ADDENDUM NO. 1

RE: The Village at Oakview
for Bristol Redevelopment and Housing Authority
BRHA-1460.00.MF.0915
T&L Project No. 12655-05

DATE: December 17, 2015

AS102

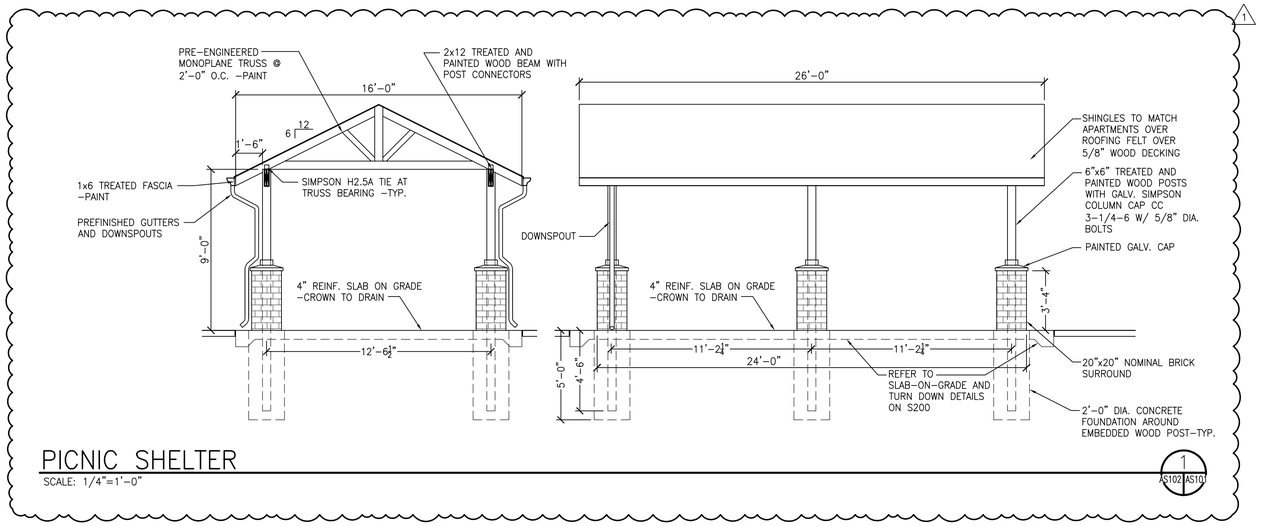
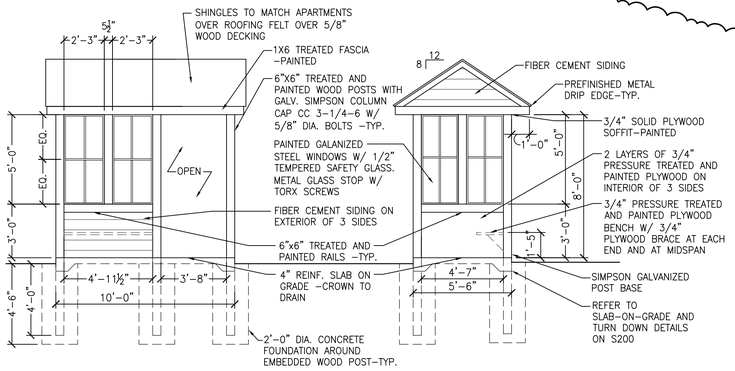
21. Could you provide a section through the bus shelter?

2. Refer to detail "1/AS102" – Provide details for the Picnic Shelter:

d. Verify 4x4 beams. Seem too small for the span.

3. Refer to detail "2/AS102" – Provide details for the Bus Shelter:

e. Provide section. Soffit required?

Response: Refer to revised Drawing Sheet AS102

Response: The requested information is shown on the updated sheet AS102.

Response: The requested information is shown on the updated sheet.

Sheet No.
C101

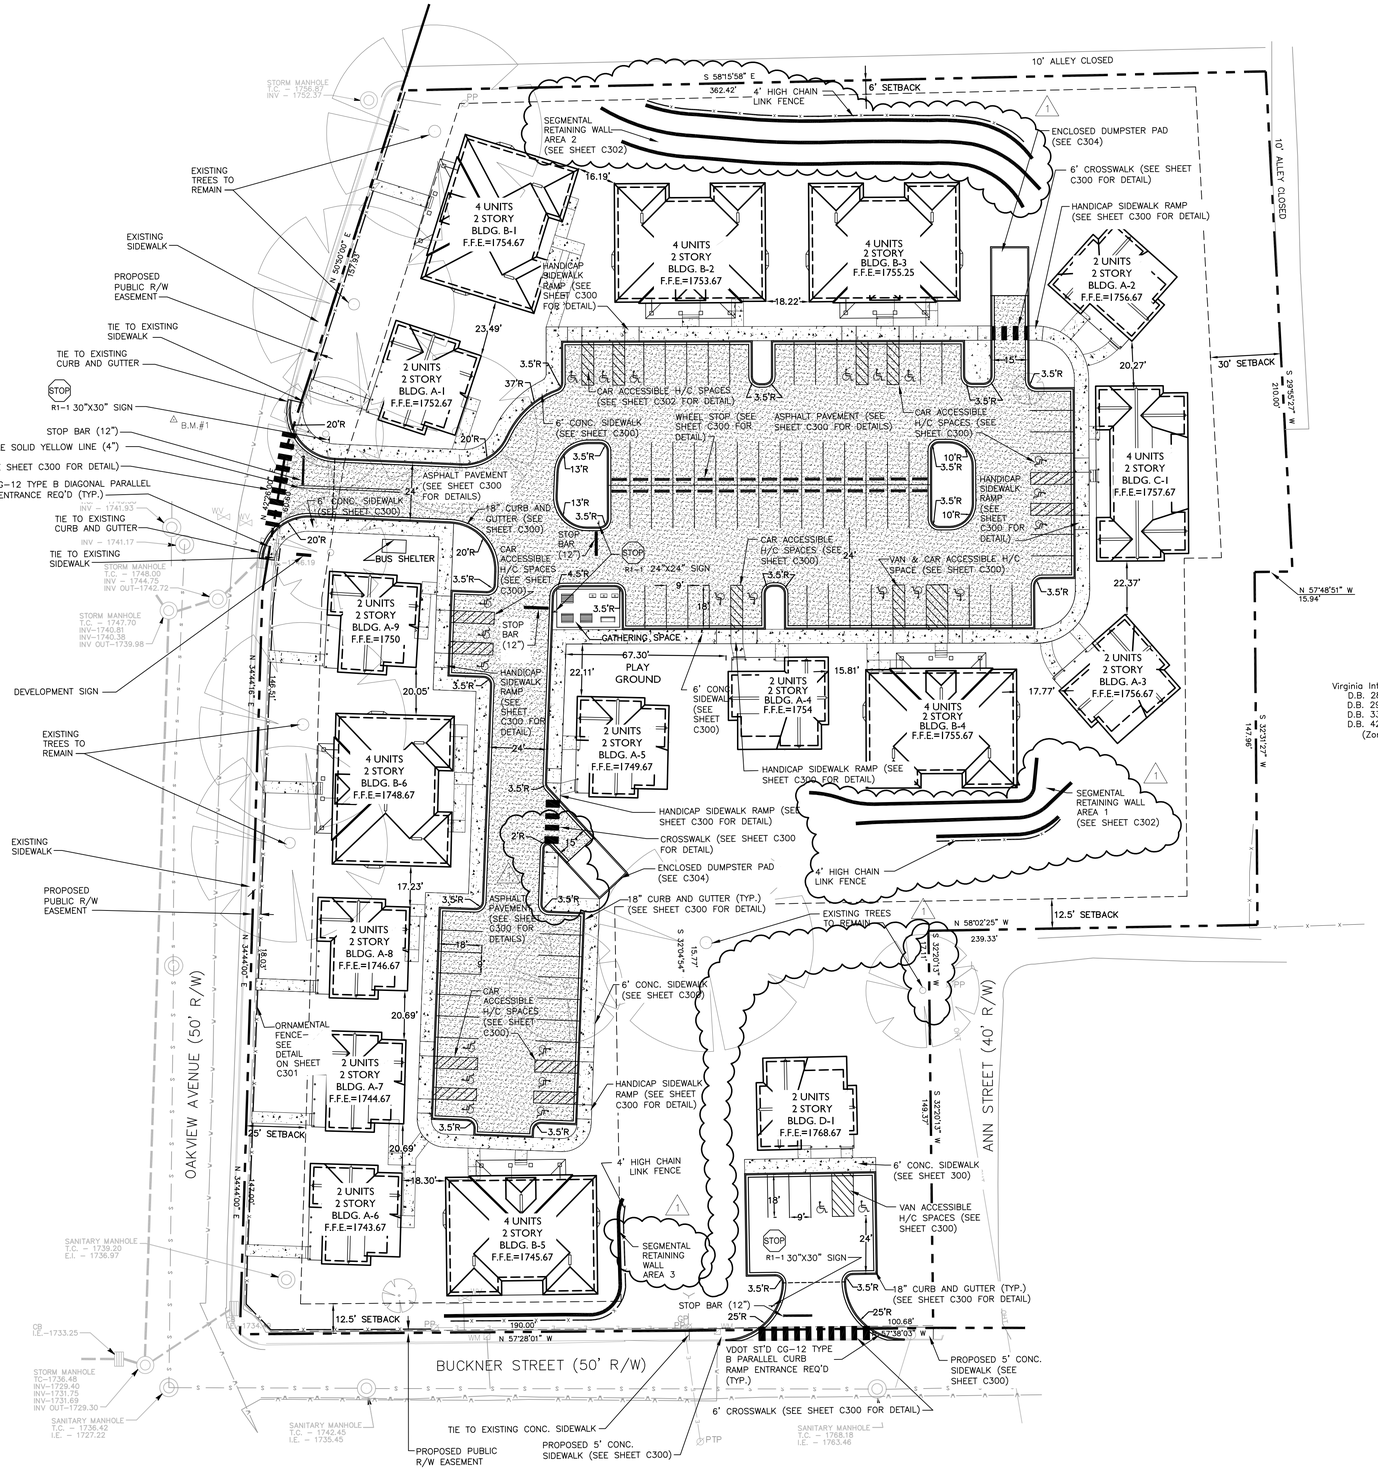
17. The C101 drawing shows a development sign at the entrance on Oakview Avenue. Is this a temporary construction sign or a permanent sign? Are there any details for this?

Response: This is a permanent sign. Refer to AS101 and Specification 10 1400-Signage.

Sheet No.
A101A

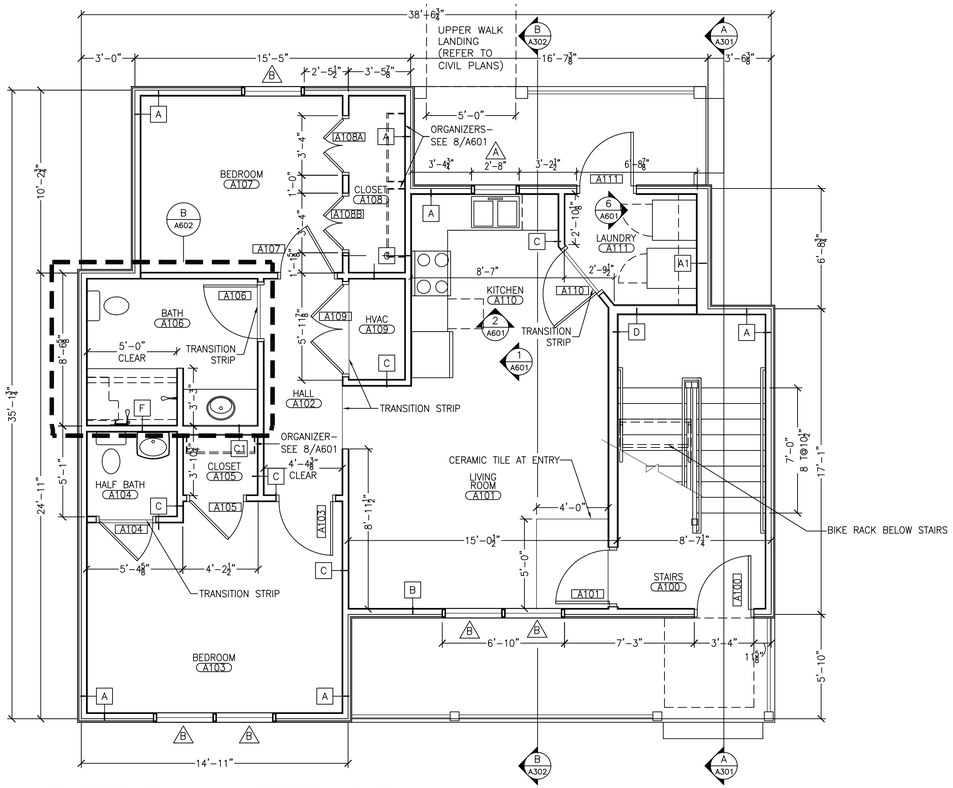
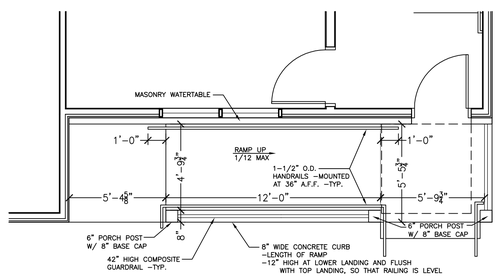
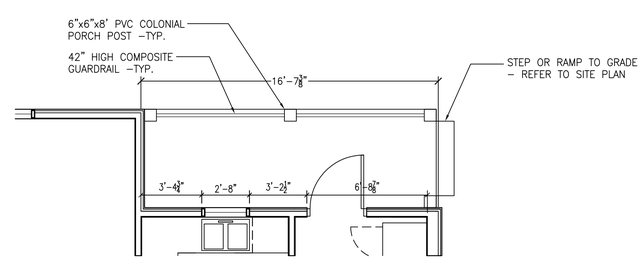
10. Refer to A101A, Bldg-A, First Floor: Please clarify. At the end of the back porch is there to be a concrete step or a rail?

Response: Installation of step or rail varies and is to be coordinated with building locations as shown on the civil drawings.

A
A301A A301A
SECTION THRU FRONT PORCH
SCALE: 3/4"=1'–0"

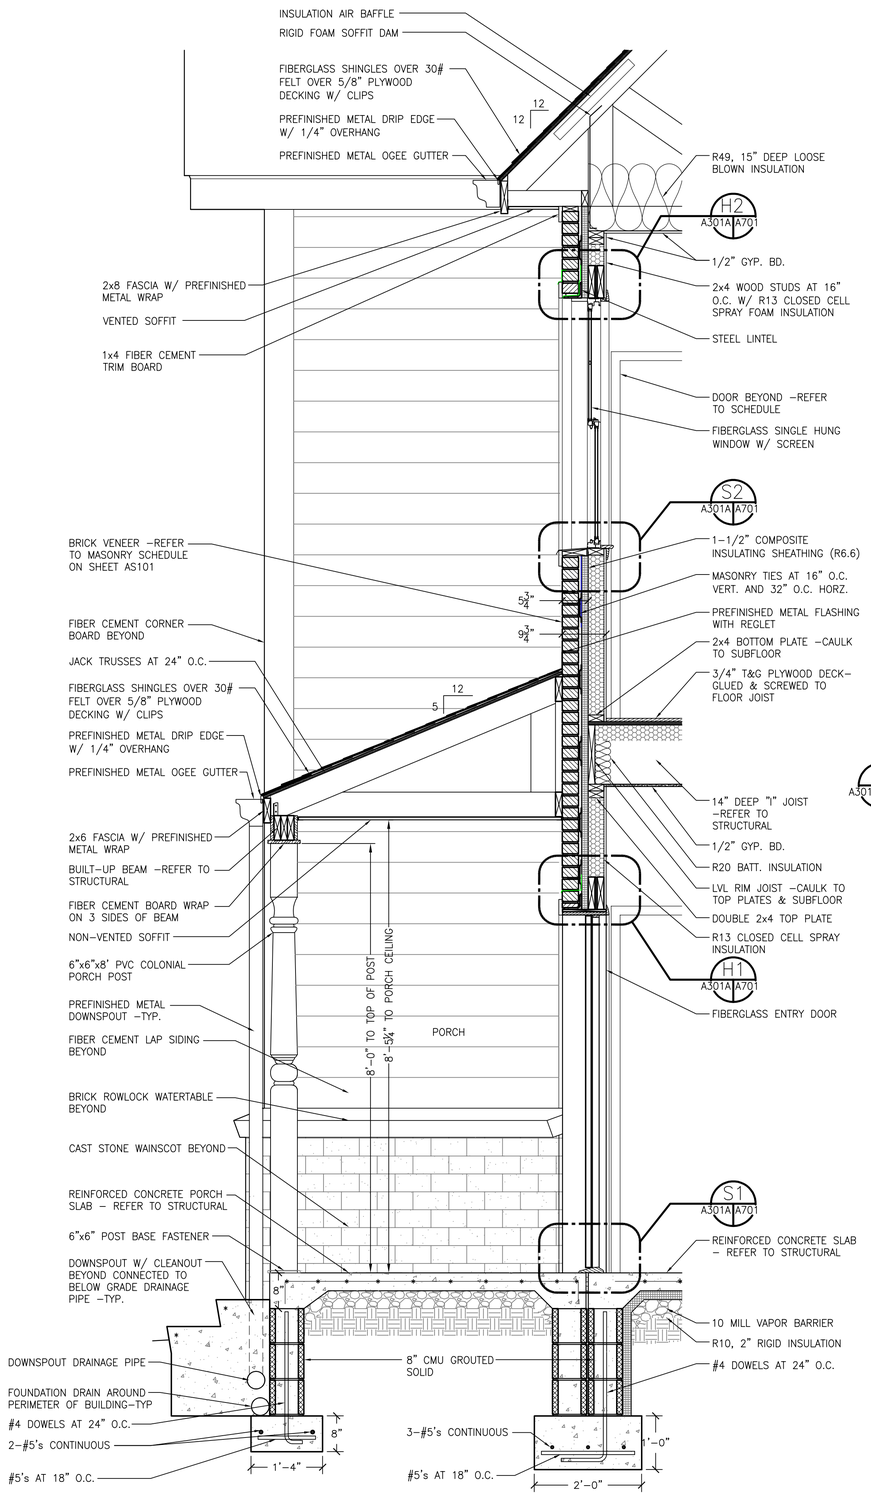
24. Re: B/A301A (typ) – It appears that the details are provided for vinyl siding although the elevations note fiber cement siding & trim. The frieze board behind the soffit is labeled as FC 1x4 but is drawn as a vinyl trim component. Please clarify.

Response: The frieze board shall be 5/4 x 3.5 inch fiber cement board.

AA
A101A A301A
BUILDING SECTION THRU STAIRS
SCALE: 3/8"=1'–0"

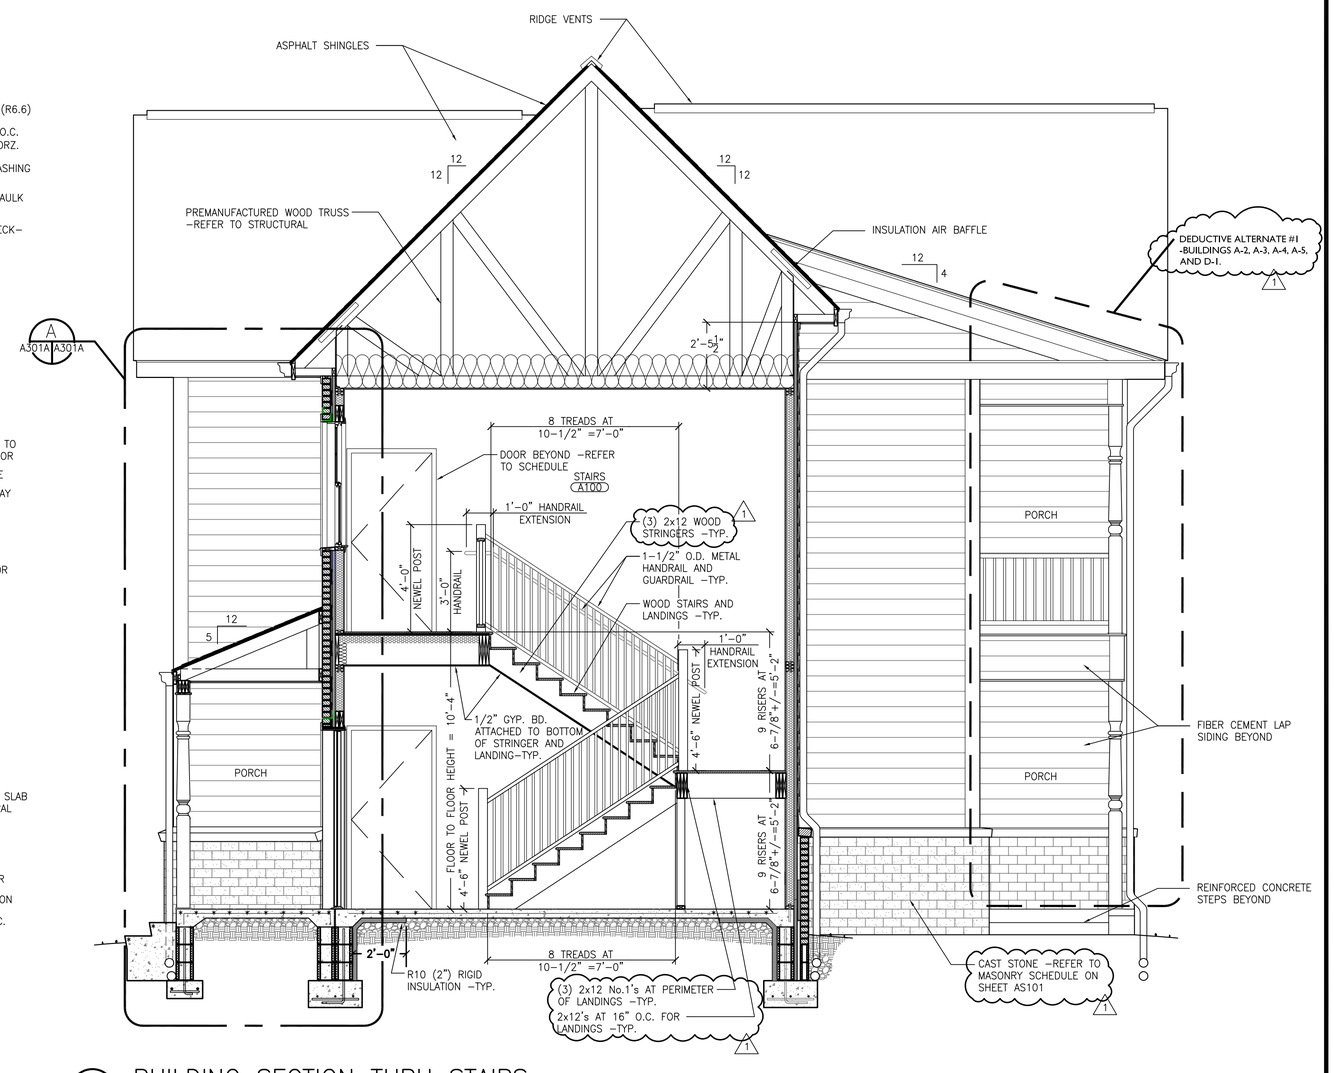
14. Refer to Building Section "AA/A301: Please provide information regarding the stair framing:

Response; 2x12 stringers notched for stairs are similar to 2x6 strength-wise. (3) stringers of double 2x12's will work. Alternatively, use un-notched 2x10's under (3) notched 2x12 stringers.

Response; (3)2x12 No. 1 at edge of landings (which support stringers). Otherwise 2x12 @ 16".

B A302A A302A SECTION THRU REAR PORCH
SCALE: 3/4"=1'–0"

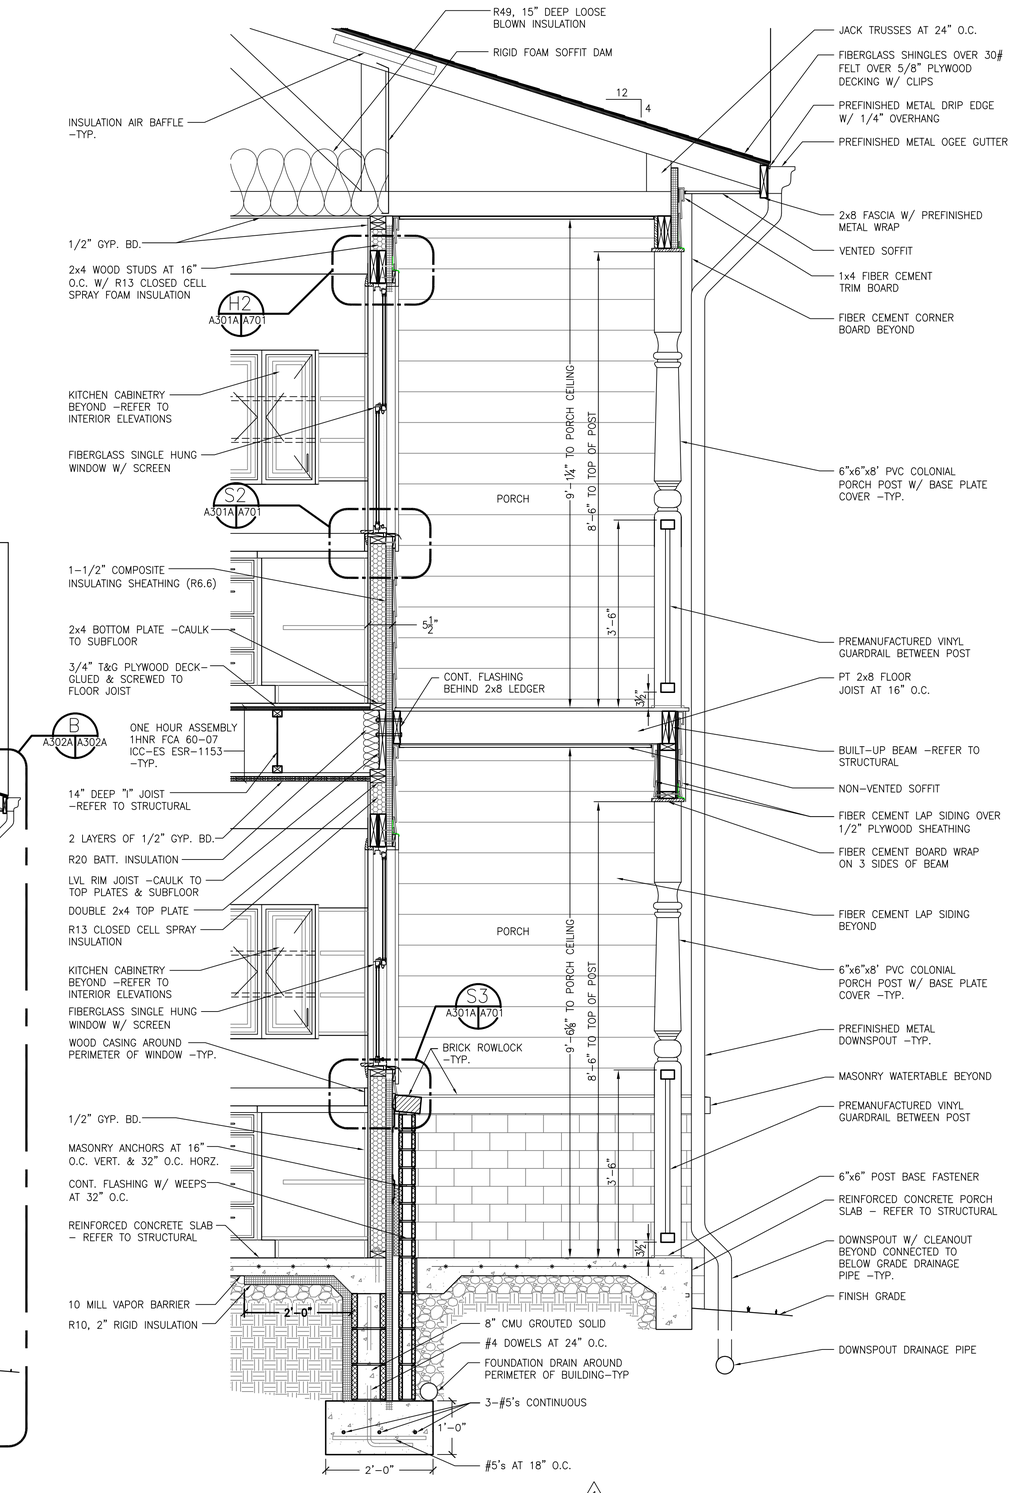
7. **Question:** Refer to detail "B/A302A" (typ) – The detail indicates something in the cavity at the base between the sheathing and the veneer. Not labeled. What is it? **Response**: The material is cavity mortar control as specified in 04 2000-Unit Masonry; Section 2.06.

11. Refer to Wall Section "B/A302A:

a. At the porch beam the note indicates fiber cement wrap on 3 sides of the beam. The detail show lap siding. Clarify the requirement.

b. Is some type of frieze indicated at the soffit. No notes to indicate anything. Clarify the detail/requirement.

23. Re: B/A302A – Verify the dimensions for the exterior slab turn-down at the porch. Detail on S200 shows 8" deep. Architectural detail is shown much deeper.

25. Re: BA302A (typ) – Are all the porch soffits to be solid or ventilated? Fiber cement or vinyl?

9. Refer to detail "B/A302A" (typ) – Specify the anchor bolt size, type and spacing.

10. Refer to detail "B/A302A" (typ) – Specify the size, spacing, etc. for the bolts supporting the ledger.

11. Refer to detail "B/A302A": What type of decking is to be used for the balcony? Nothing is indicated.

Response: Lap siding shall be installed on two sides with fiber cement board wrap on the bottom of the porch beam.

Response: Install 5/4 by 3.5" tall trim board at top of lap siding -typical.

Response: The exterior slab turn-down shall be 24" deep.

Response: The front porch and second floor rear porch soffits shall be non-vented fiber cement soffits. The first floor rear porch shall not have a soffit on the base bid design. The first floor rear porch Deductive Alternate-1 design shall have a non-vented fiber cement soffit.

Response: Sill plate anchor bolts are ½” diameter with 9” embedment at 48” on center.

Response: Connect 2x8 ledger to LVL rim joist with ½" diameter through-bolts at 16" on center.

Response: The second floor porch deck boards shall be pressure treated 1x6 material.

Sheet No.
A304B

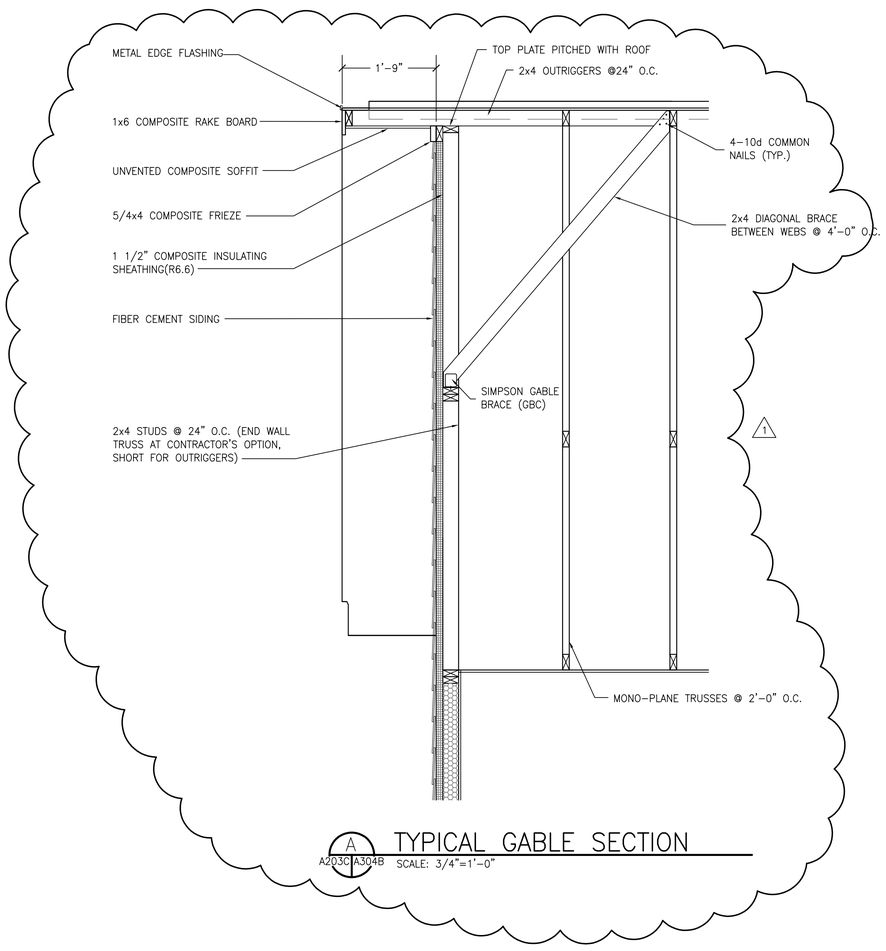
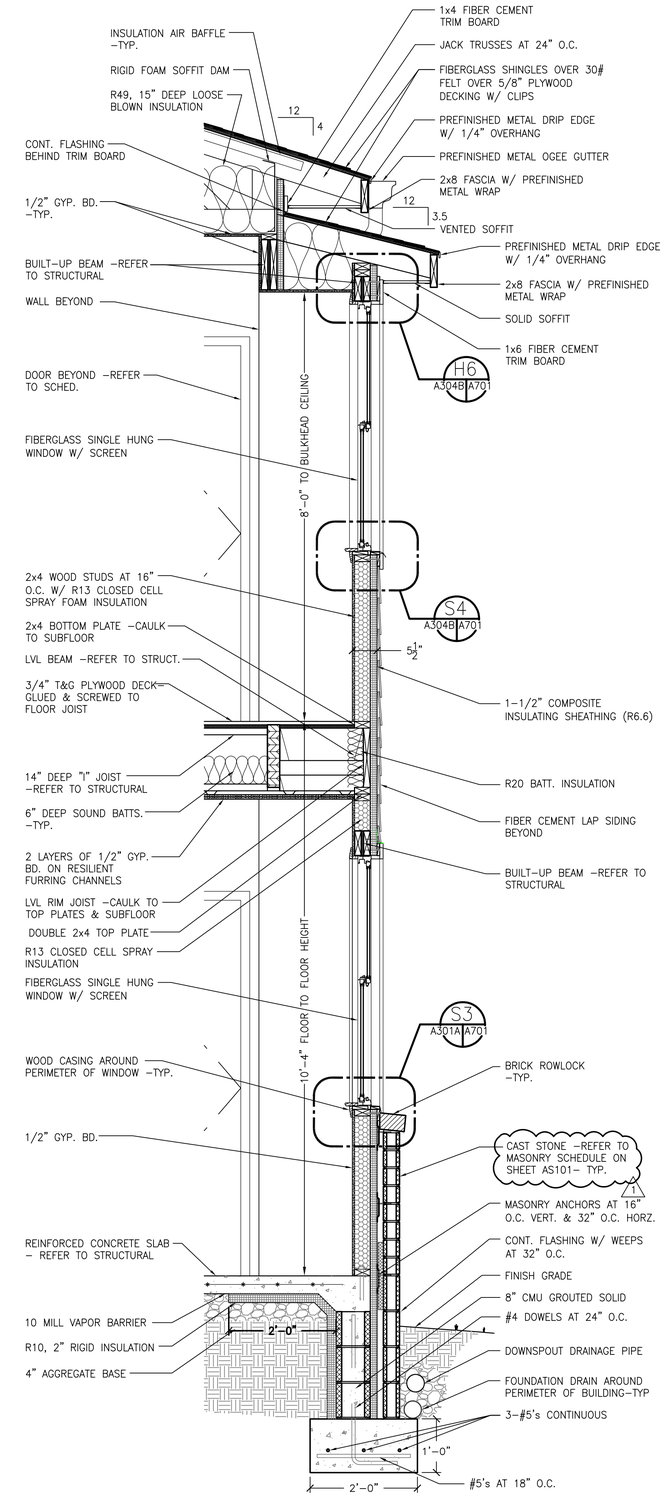
22. Re: Building A, D – Provide section at rake and gables. How is the rake, overhang to be framed? Provide dimensions. How is the gable to be framed? Is insulation sheathing required? Provide soffit and rake trim details, dimensions.

13. Refer to detail "B/A304B": There appears to be a conflict in the roof framing over the bay windows. The architectural detail is different from the structural detail (2/S300). Please clarify.

Response: Refer to revised Drawing Sheet A304B

Response: The architectural detail is the correct detail. Add a wood 2x4 above the ceiling along the bump-out wall for support of the gypsum board edge.
